### TRI-PARTY AGREEMENT

Change Notice Number TPA-CN- 0784	TPA CHANGE NOTICE FORM	Date: 5/31/2017
Document Number, Title, and Revision: DOE/RL-2014-13-ADD2 Rev 0: Remedial Design Report Remedial Action Work Plan Addendum for the 300 Area Groundwater <b>1229943</b>		Date Document Last Issued: 6/10/2015
Approved Change Notices Against this Document: TPA-CN-700		
Originator: S. N. Balone		Phone: 376-0236

**Description of Change:**  
Figure 7-1, Schedule for Groundwater Remedy Implementation, is being replaced with an updated schedule.

Figure 7-1, Schedule for Groundwater Remedy Implementation

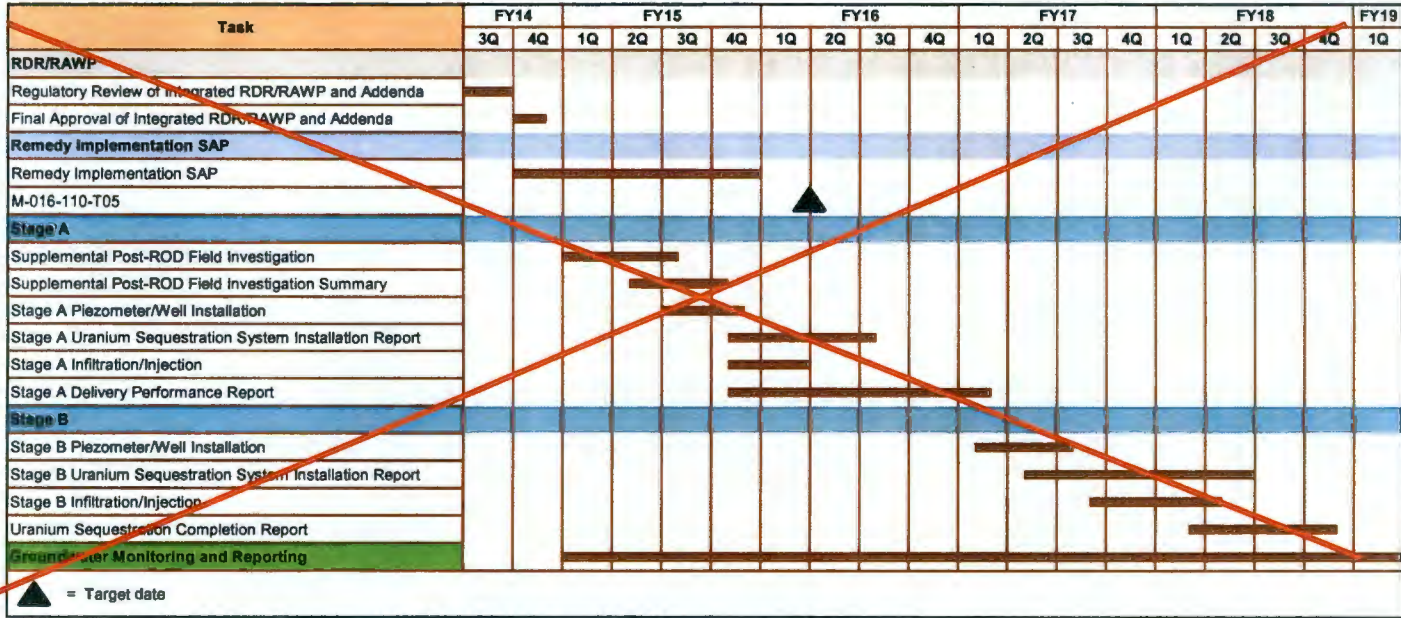
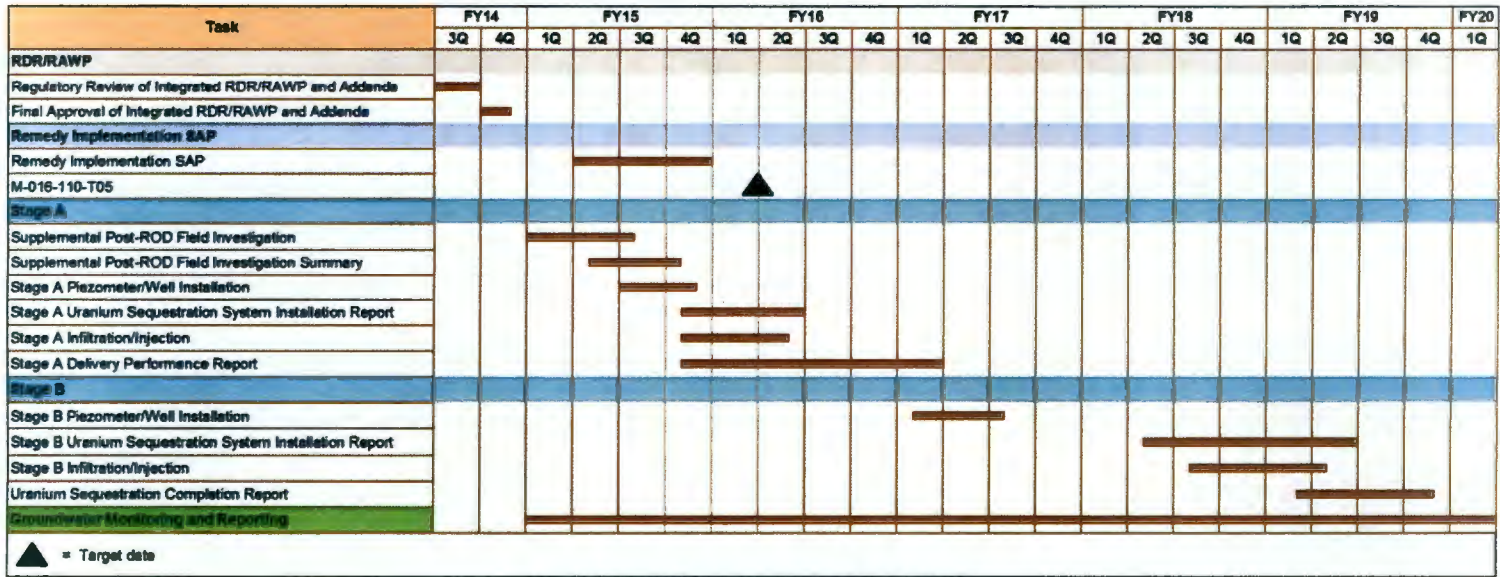
J.R. Franco **DOE** and B.W. Simes **Lead Regulatory Agency** agree that the proposed change modifies an approved workplan/document and will be processed in accordance with the Tri-Party Agreement Action Plan, Section 9.0, *Documentation and Records*, and not Chapter 12.0, *Changes to the Agreement*.  
Figure 7-1 on page 7-2 (as modified by TPA-CN-700) is replaced with a new figure to reflect the postponement of the Stage B Uranium Sequestration System Installation Completion Report, completion of the Stage B Uranium Infiltration/Injection, and the Uranium Sequestration Completion Report.

**Justification and Impacts of Change:**  
The schedule for Stage B is postponed to perform and evaluate additional groundwater monitoring. This postponement reflects the agreement between RL and EPA reached during our meeting on May 30, 2017.
